# Access Compliance Report

## Public Rights-of-Way

Intersection ID: 16670	Main Street: BEVERLY_DR	Cross Street: PROVIDENCE_RD	Location: NW
ADA ID: D36018F21F17	Ramp Type: Perp	Initial Pass/Fail: Fail	Overall Compliance: No
Severity Score: 17.5			
Codes/Mitigation Info/Possible Solution		Field Measurements/Component Compliance

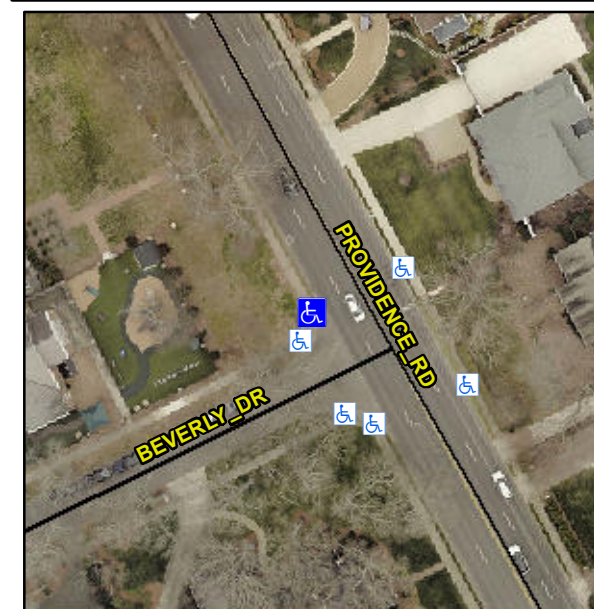
**Not Found, R304.5.1**

Compliance	Description	Data	Compliance	Description	Data
N/A	Ramp Length (in)	62.0	Yes	Ramp Slope (%)	5.4
No	Ramp Width (in)	34.0	Yes	Ramp XSlope (%)	0.1
N/A	Flare Type LT	N/A	N/A	Flare Type RT	N/A
N/A	Flare Slope LT (%)	N/A	N/A	Flare Slope RT (%)	N/A
N/A	Flare Traversable LT?	N/A	N/A	Flare Traversable RT?	N/A
N/A	Landing Length (in)	N/A	N/A	DWS Provided?	N/A
N/A	Landing Width (in)	N/A	N/A	DWS Contrast?	N/A
N/A	Landing Slope (%)	N/A	N/A	DWS Length (in)	N/A
N/A	Landing X Slope (%)	N/A	N/A	DWS Full Width?	N/A
N/A	Landing Curb? (Y/N)	N/A	N/A	DWS Offset (in)	N/A
N/A	Shared Landing?	N/A			
N/A	Gutter Ponding?	N/A	N/A	Gutter Slope (%)	N/A
N/A	Gutter Lip Ht (in)	N/A	N/A	Gutter X Slope (%)	N/A
N/A	Painted X Walk1?	No	N/A	Painted X Walk2?	N/A
	X Walk 1 Direction	To NE		X Walk 2 Direction	N/A
N/A	X Walk 1 Width (in)	N/A	N/A	X Walk 2 Width (in)	N/A
	X Walk 1 Slope (%)	4.2		X Walk 2 Slope (%)	N/A
	X Walk 1 X Slope (%)	1.9		X Walk 2 X Slope (%)	N/A

**Remove & Replace Entire Ramp.**
